SUBJECT: Forwards marked-up final draft Tech Specs & itemized list of corrections. *566 TECH SPGS*

## Arizona Nuclear Power Project

Subject: PVNGS Unit 1  
PVNGS Unit 1 Final Draft Technical  
Specifications  
Docket No. STN 50-528  
File: 005-419.05

This letter is submitted for the purpose of (i) transmitting a marked-up copy of the "Final Draft" Technical Specifications (Attachment A) and an itemized list of corrections included in such marked-up copy (Attachment B) and (ii) providing our certification respecting Attachment A.

FIGURE 3.1-2A  
PART LENGTH CEA INSERTION LIMIT vs THERMAL POWER

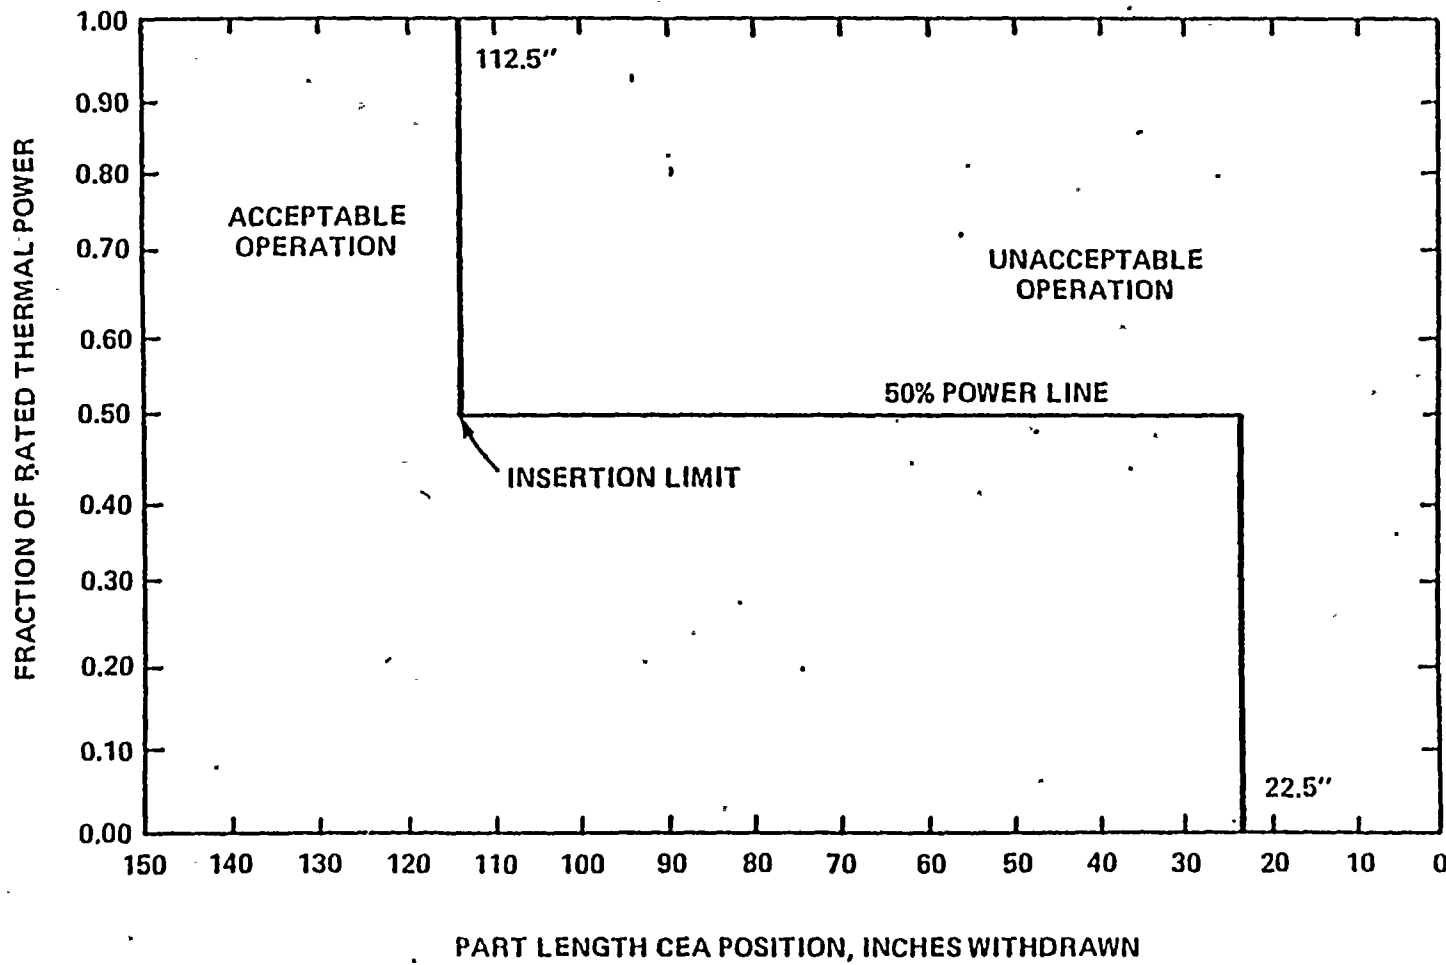
- c. With one or more full-length or part-length CEAs misaligned from any other CEAs in its group by more than 6.6 inches, operation in MODES 1 and 2 may continue, provided ~~within 1 hour~~ that core power is reduced in accordance with Figure 3.1-2B and the misaligned CEA(s) is either:  
THAT WITHIN 1 HOUR

FIGURE 3.2-3  
REACTOR COOLANT COLD LEG TEMPERATURE vs CORE POWER LEVEL

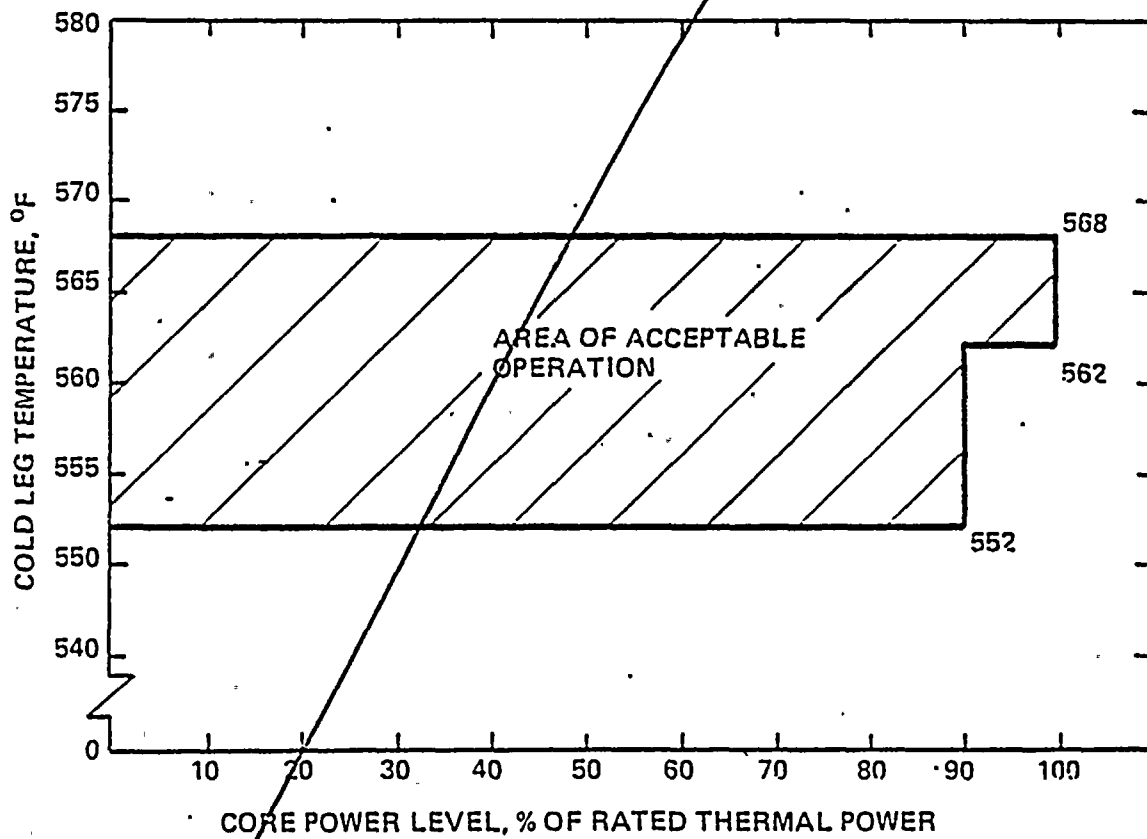
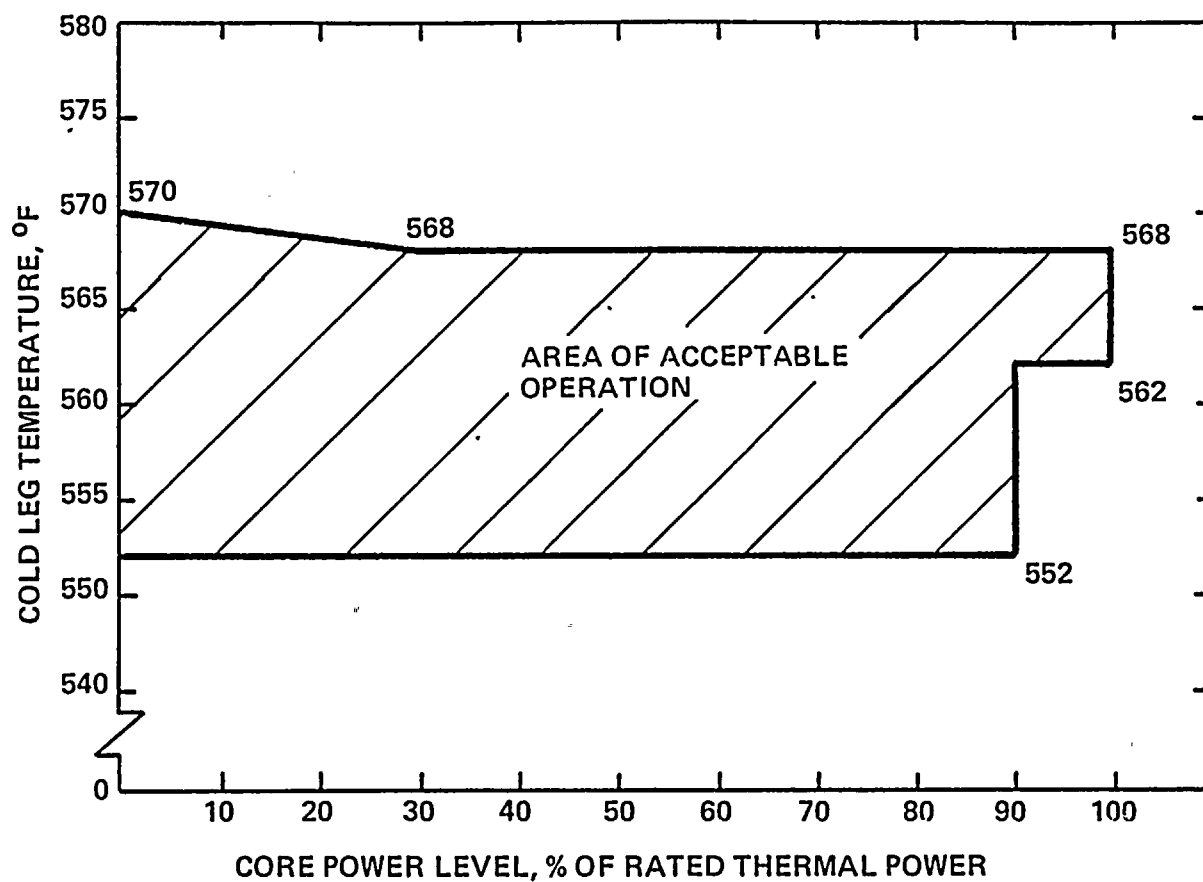
SEE  
NEW  
GRAPH
